GENOA CHARTER TOWNSHIP PLANNING COMMISSION PUBLIC HEARING AUGUST 12, 2013 6:30 P.M. AGENDA

Attention:	Kelly Van Marter, AICP
	Assistant Township Manager and Planning Director
Subject:	Dr. Rondeau Dental Office – Special Land Use and Site Plan Review #2
Location:	Grand River Avenue – north side of Grand River, east of Kellogg Road
Zoning:	OSD Office Service District

Re: Rondeau Dental Office Site Plan Review #2

RE: Rondeau Dental Office N. side of Grand River – East of Kellogg Rd. Revised Site Plan Review

7/10/13 SHEET NO. **C6**

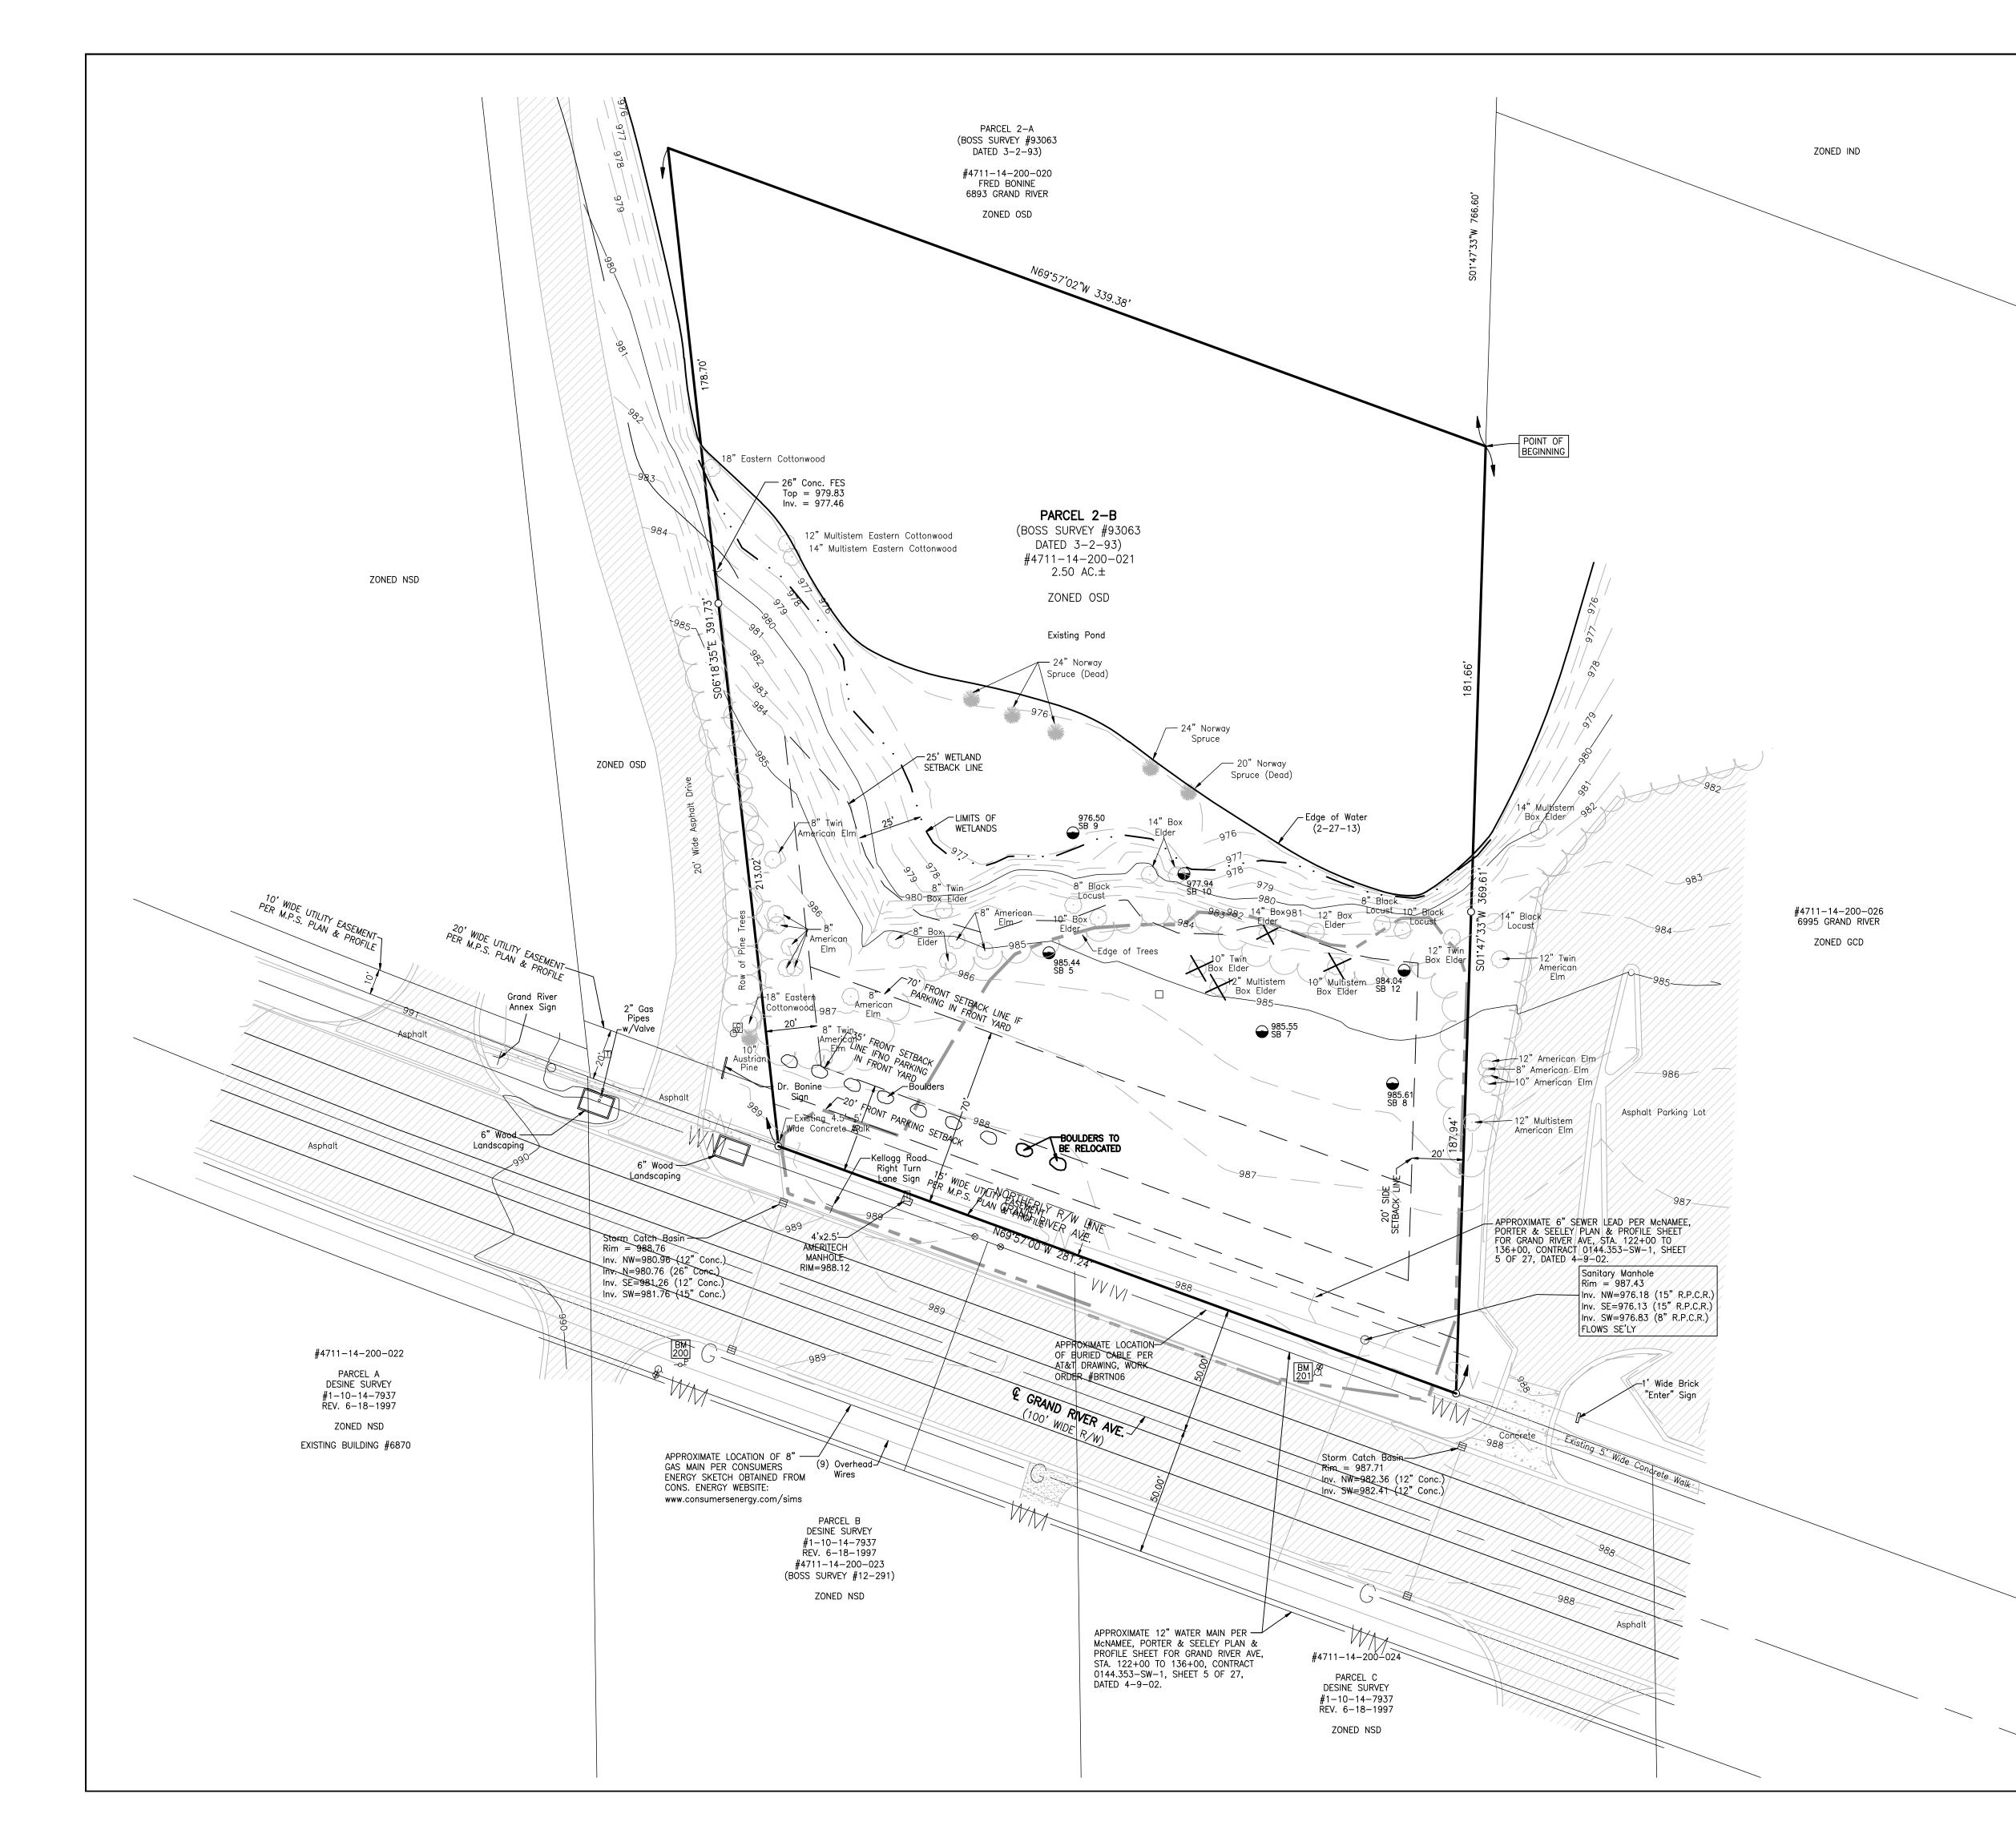
- **9.** Exterior Lighting. Sheet C6 proposes two light poles in the parking lot. Pole height and light intensity readings comply with Section 12.03. A fixture detail has been added to Sheet C9, indicating use of downward directed, cut off fixtures, as required.
